LETTER OF SUBMITTAL
KFM Skyway Project # 04-012024

Subject: USI - Closeout Letter for NCR 165

Subject: Response to Caltran/Mets NCR# 155

Subject: KFM/USI NCR No. 155: Failure to Follow Requirements for Critical Weld Repairs

NCR #155

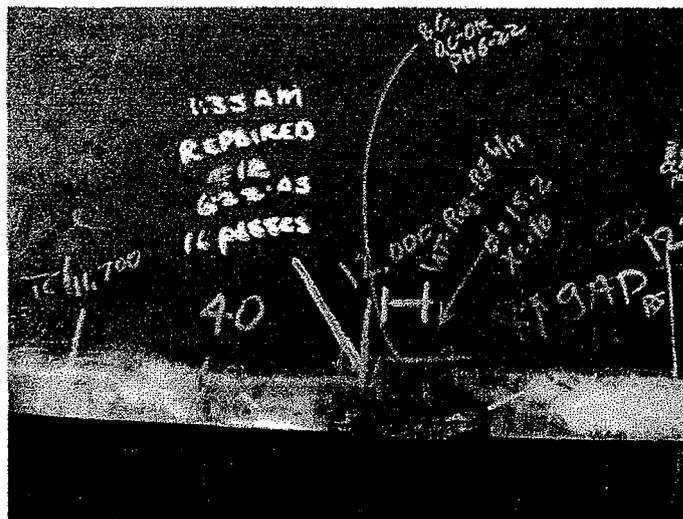
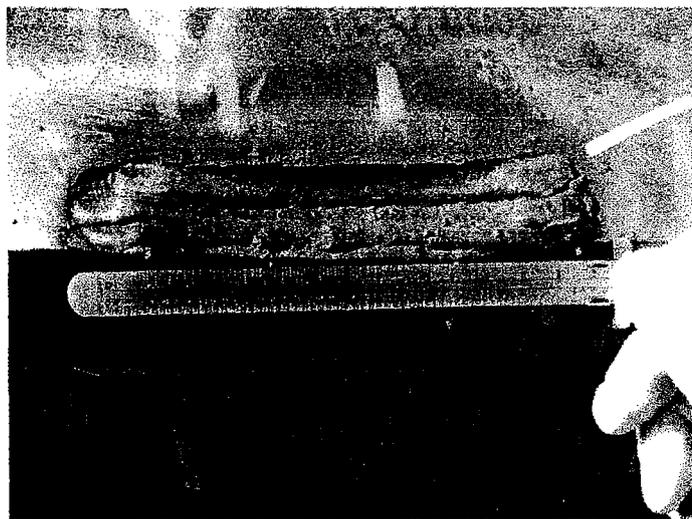
Description of Non-Conformance: KFM's Quality Control (QC) Manager and on-site representatives allowed USI to perform a critical weld repair (CWR) without following the requirements in AWS D1.5:96, section 12.15.1.1 and USI's internal repair procedure 9.0.1 rev. 4, paragraph 6.1.2.1. One area of CWR 05-252 R1 (weld joint 410 of diagonal plate Pa339 to 100 mm plate) was excavated, and 16 passes were welded on the evening of 06/22/2005. This repair area was allowed to cool overnight without completion. The following photographs depict the repair area after being allowed to cool.

Applicable reference: AWS D1.5:96, section 12.15.1.1, which states, "When postheat is required, the weld shall not be allowed to cool below the minimum preheat and interpass temperature before being raised to the postweld heat treatment (PWHT) temperature."

USI internal repair procedure 9.0.1 rev. 4, paragraph 6.1.2.1, which states, "For critical status repairs and noncritical status repairs that require postheat, the weld shall not be allowed to cool from the time welding starts through the time that hydrogen diffusion post heating begins."

CWR# 05-252R1 is complete and the follow up NDE is acceptable.

This incident occurred due to two factors. Firstly, the welder involved was unaware of the proper procedure and consequences of leaving a critical weld repair incomplete. Second, the immediate supervisor was unaware that this was a violation. After this incident, all welders and supervisors were informed of the proper welding procedure. All weld repairs since were performed by welders with intent of completion within the parameters of the weld procedure.
